From: Geoff Gibbs [REDACTED]
Sent: 20 September 2017 15:40
To: Michael Eastham
Subject: Fwd: Objection to A/99/17/OUT

Planning Application Reference A/99/17/OUT

Land South of Water Lane, Angmering

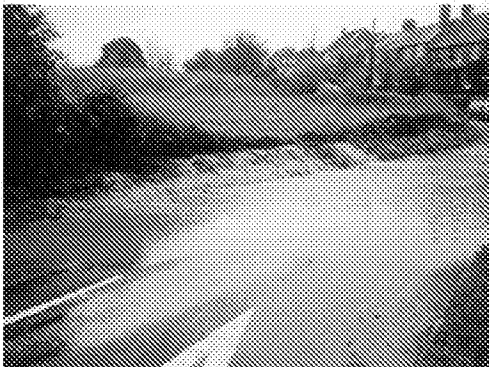
This second photograph below shows flood water running off the area immediately to north of the western part of the site.
